Horace Mann Elementary School

FS Phase

SBC/DRC Meeting

September 22, 2022

Conceptual Site Plan Comments

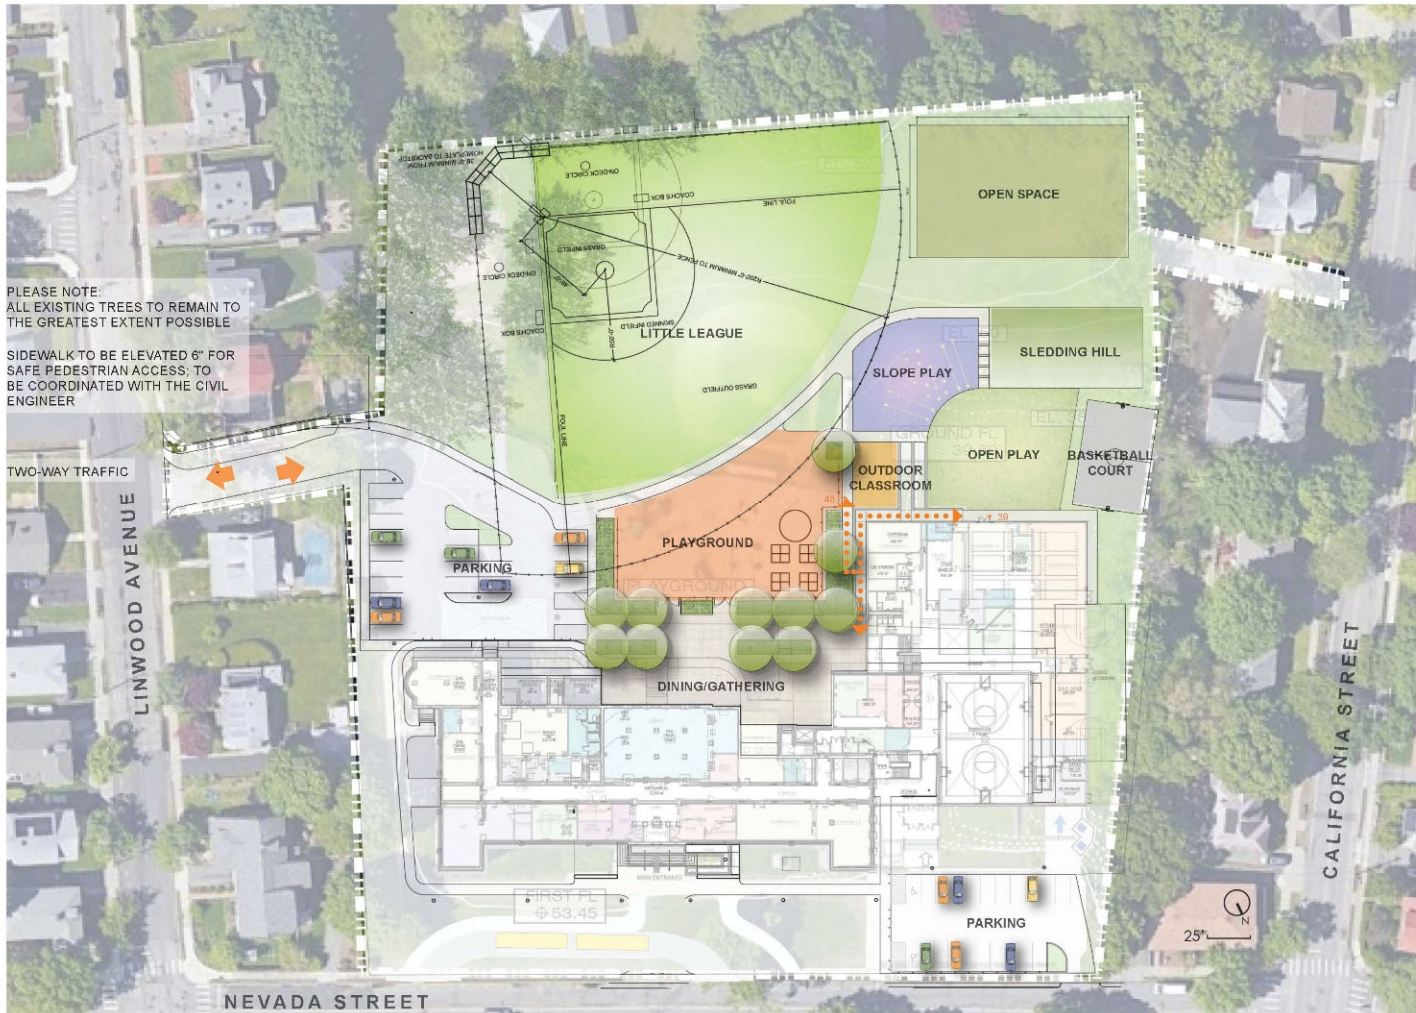
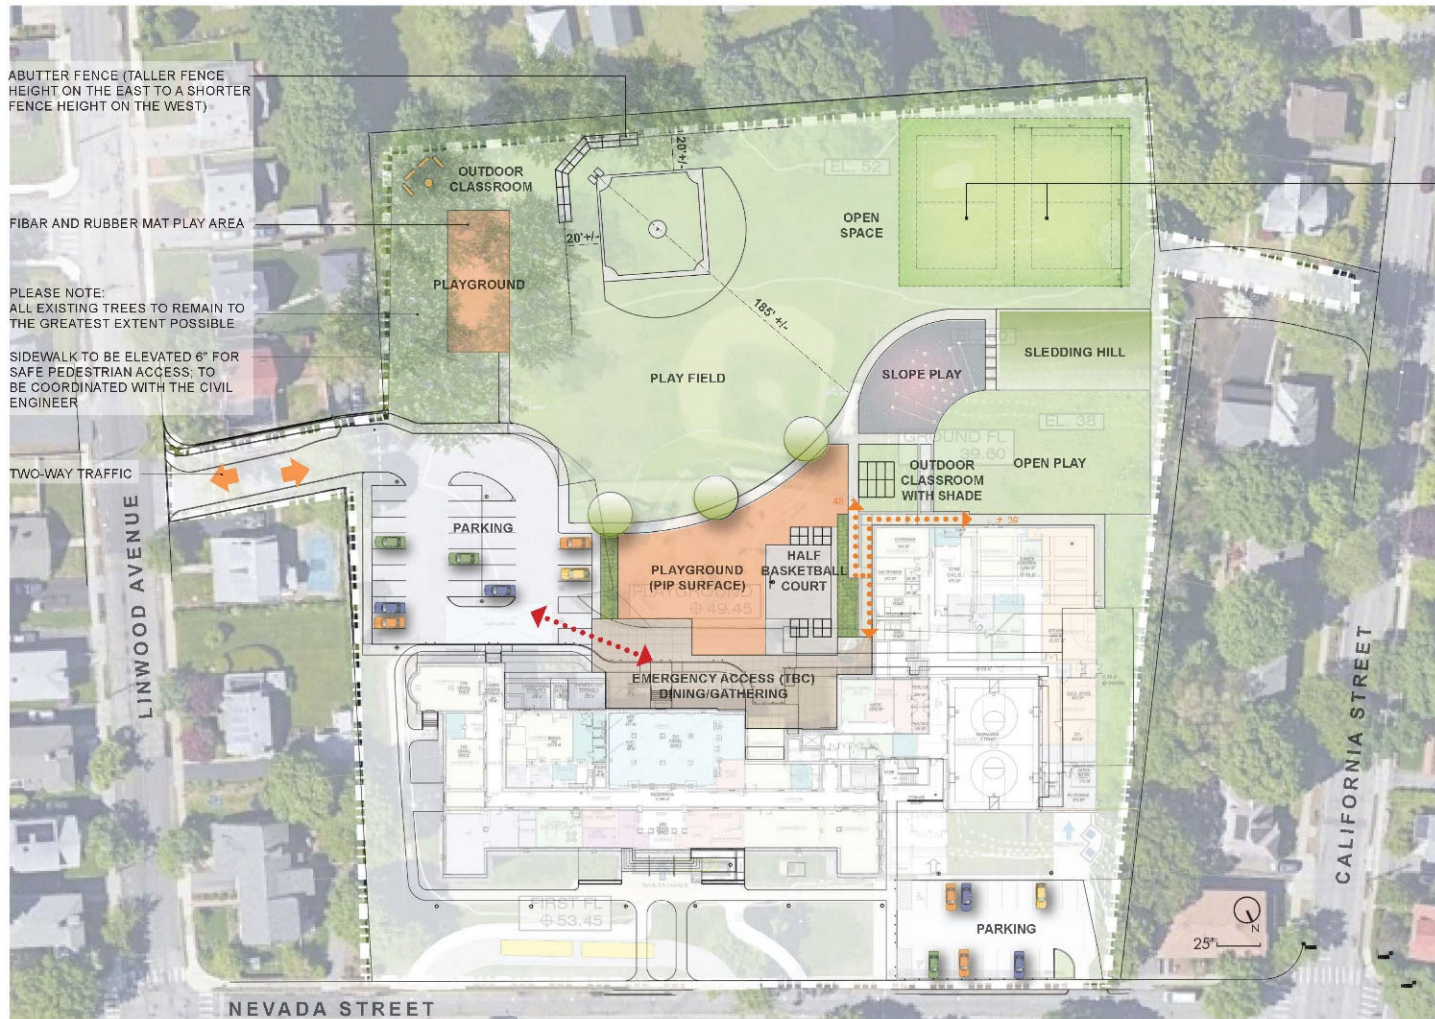
SBC/DRC Feedback:

- Flipping the Diamond Works
Provides Contiguous Open Field
- Keep the Playground in Trees
Shaded
Flexibility
Safe During Construction
- Don't Remove ANY Trees
- Smaller Baseball Field is OK
- Incorporate Youth Soccer Fields (*U8/U10*)
- Explore Half-Court Basketball Up Top w/Playground

Working Group Feedback:

- Use Trees to Shade the Large Playground
- Don't Have Bball's Hit the Building
